## ADDENDUM #1 TO SPEC. 07-177

June 7, 2007

Demolition of One (1) Building; General Site Demolition; Site grading; Removal of Underground Storage Tanks; Disposal of Impacted Soils; and Sediment and Erosion Control North of "O" Street and East of 50<sup>th</sup> Street at 5000 'O' Street

## Sanitary Sewer Service Record

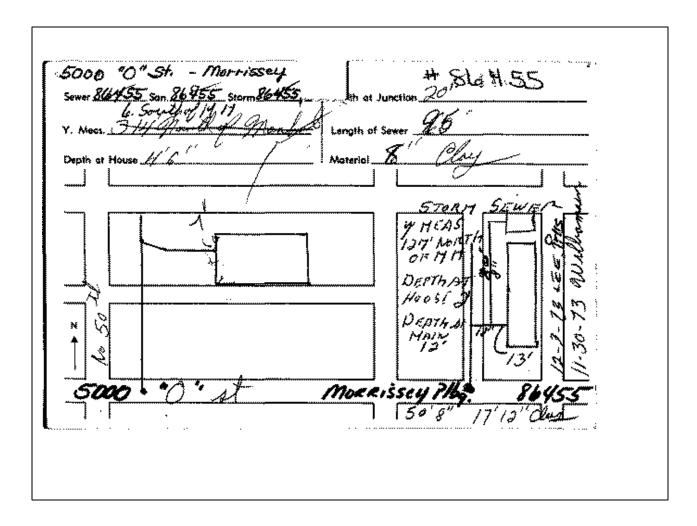
Will the sanitary sewer service line need to be abandoned?

Yes. The sewer service will need to be abandoned at the main. The service is connected to a main that runs parallel to 50<sup>th</sup> Street (see attached sketch on page 3).

Service line connects to an 8" VCP that is located in the parking lot on the west side of the property.
